Addendum #3

Re: Beaufort County Animal Shelter and Hilton Head Humane Association Animal Services Complex
Beaufort County, SC
10 Pritcher Point Road, Okatie, SC 29909
Bid Number: #041817E

This Addendum forms a part of the Contract Documents and modifies the original drawings and specifications dated 03/02/2017. Contractor shall be responsible to review changes to all portions of the work as changes of one portion may affect the work of another. Contractor shall indicate receipt of this addendum on the bid form.

COVERED STORAGE ELEVATIONS

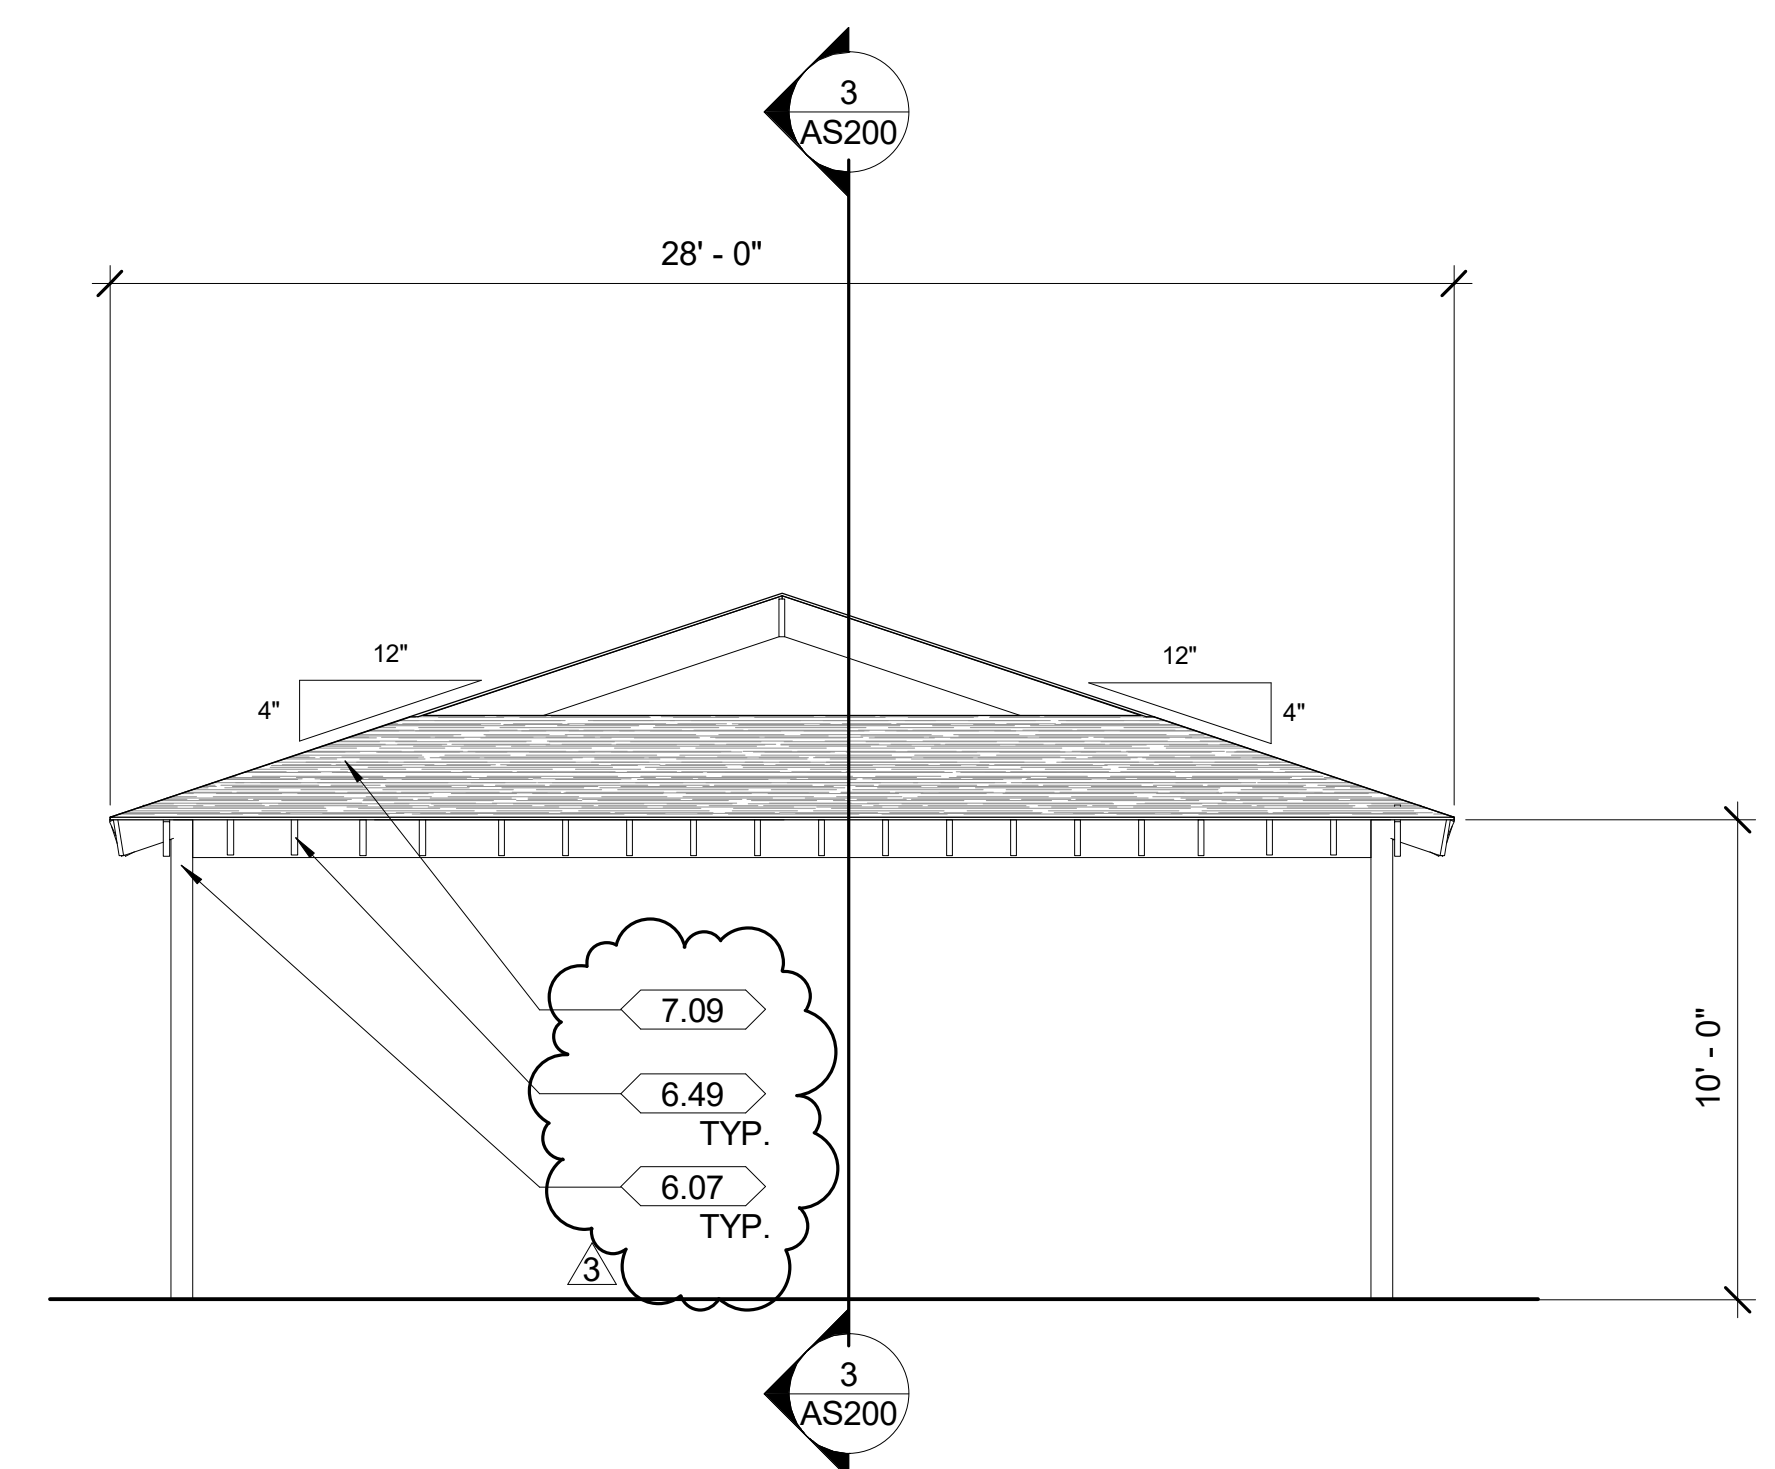
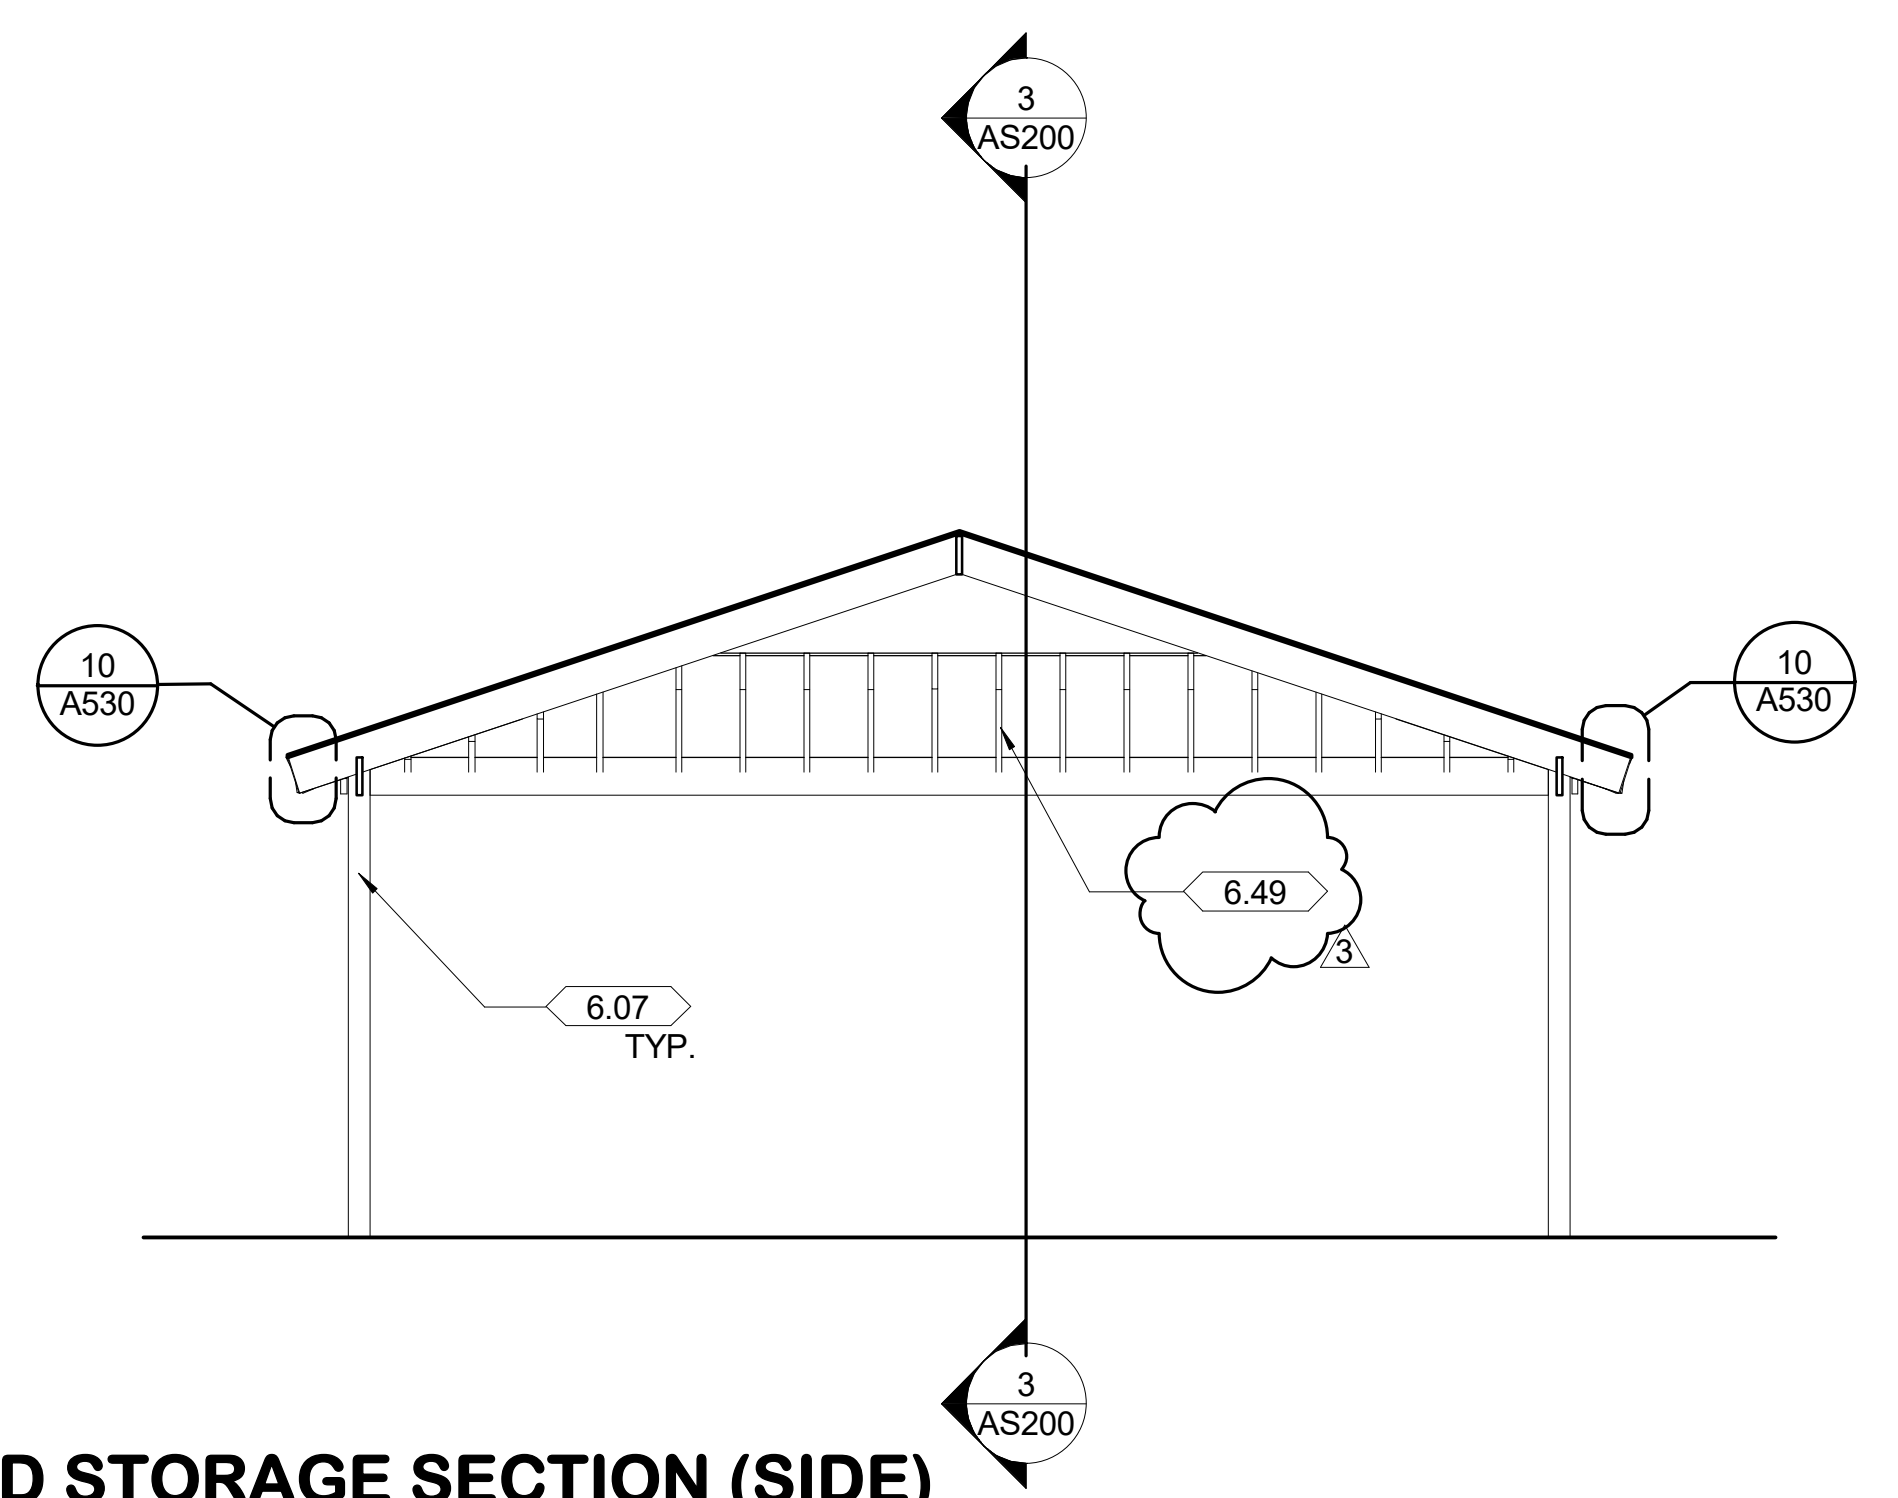
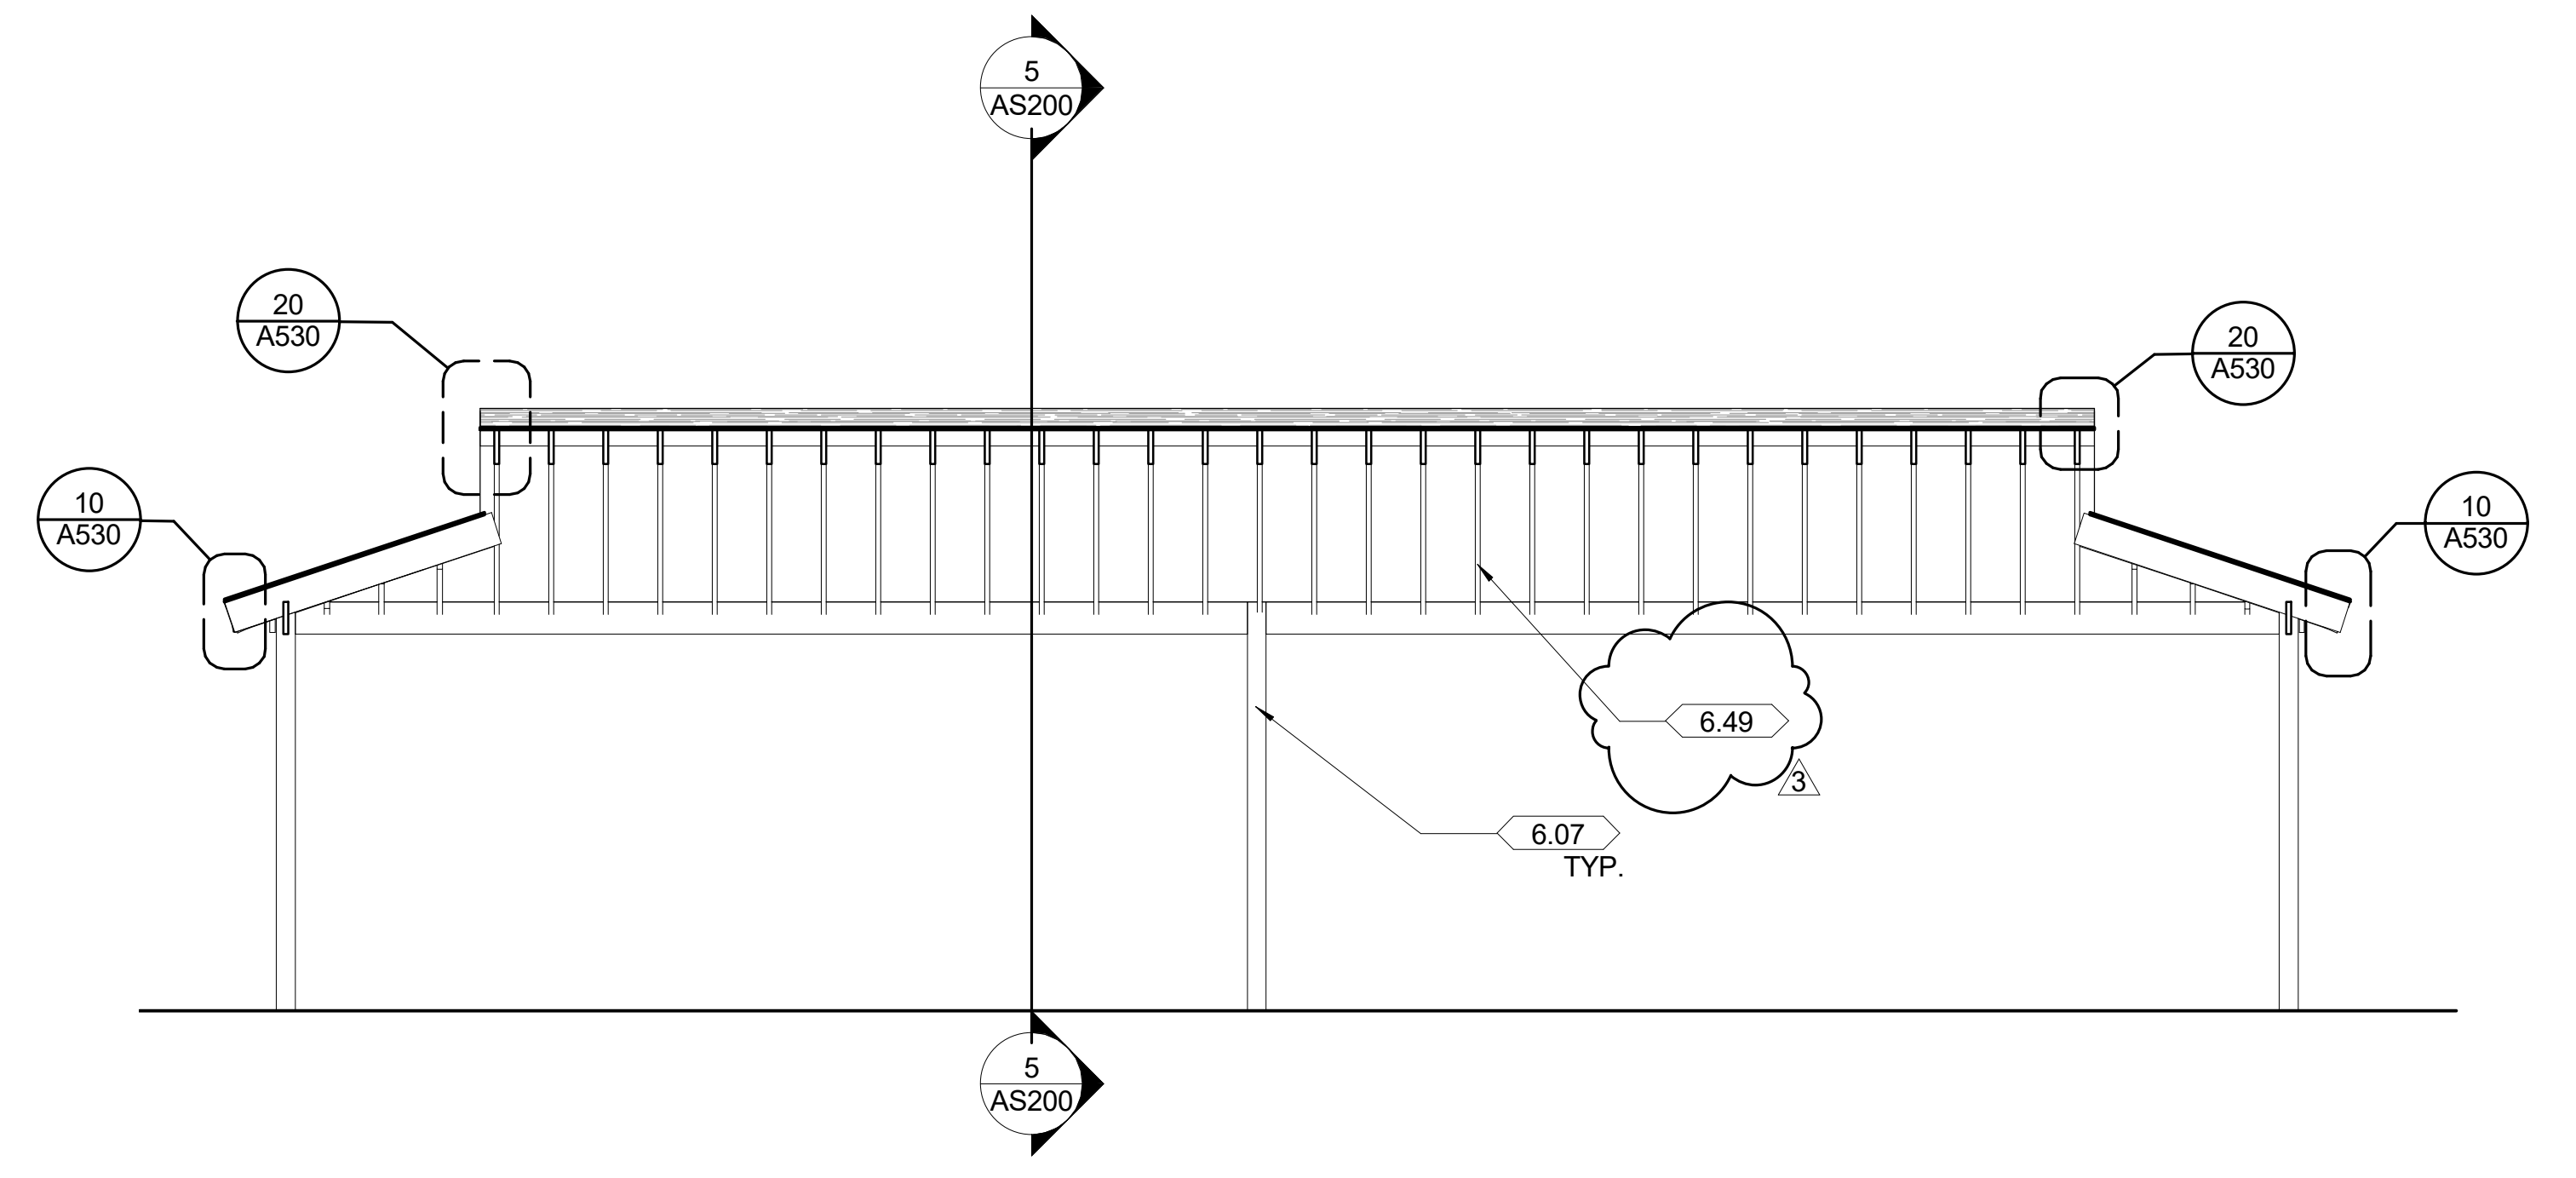
1. Revise Keynotes 6.34 and 6.41 to be Keynote 6.49. Keynote description as shown on attached Sheet.
2. Revise Keynote 6.07 to read as shown on attached Sheet.
3. Refer to attached Sheet.
